CALLAWAY PLANT, UNIT 1

AMENDMENT TO FACILITY OPERATING LICENSE

Amendment No. 12
License No. NPF-30

ATTACHMENT TO LICENSE AMENDMENT NO. 12

FIGURE 3.9-1

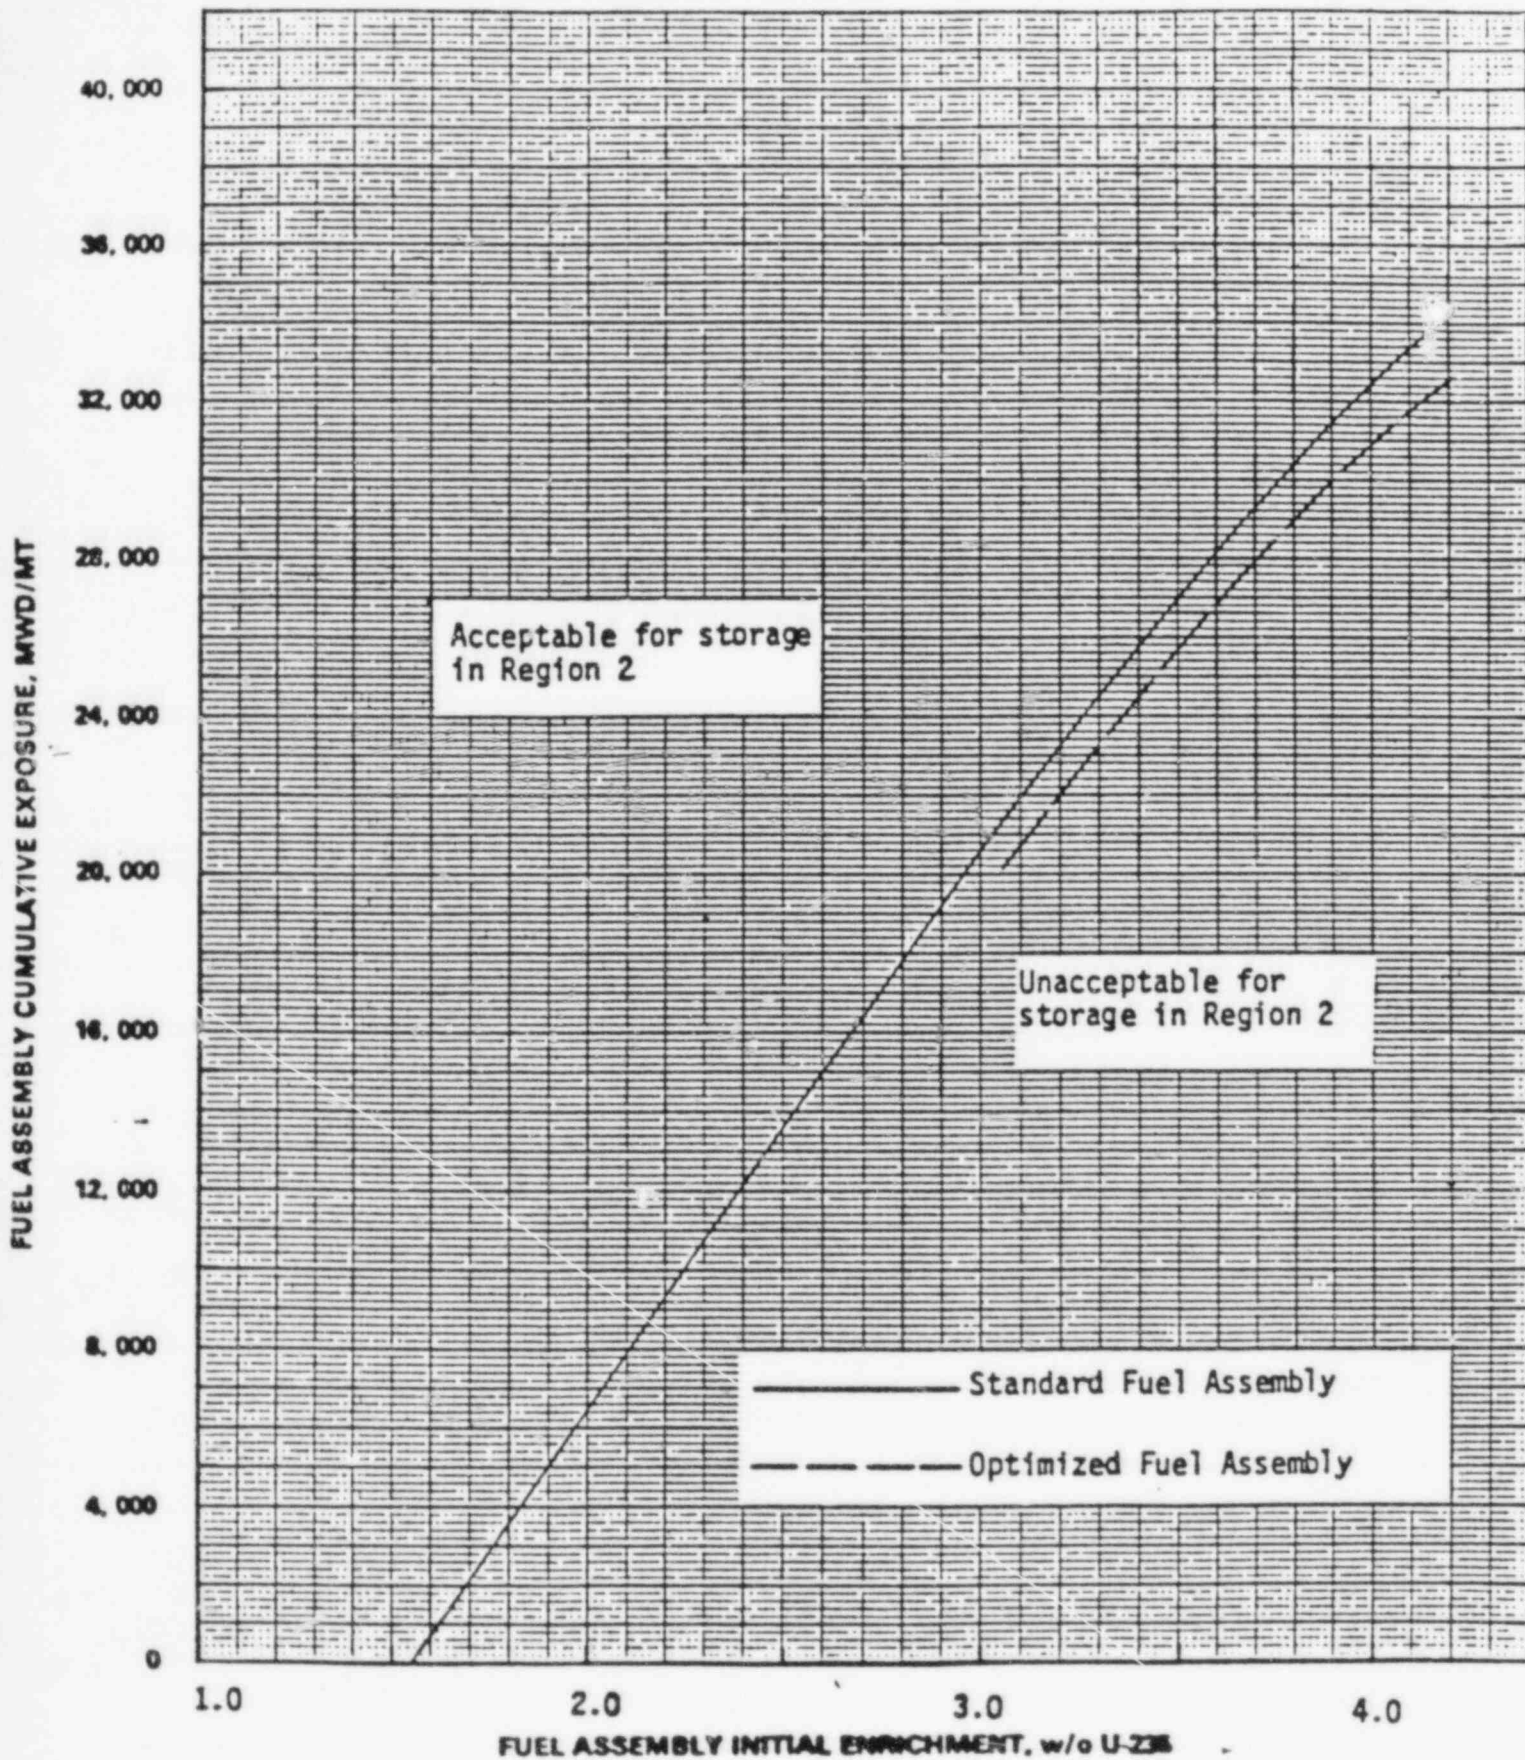
MINIMUM REQUIRED FUEL ASSEMBLY EXPOSURE AS A FUNCTION OF INITIAL ENRICHMENT TO PERMIT STORAGE IN REGION 2
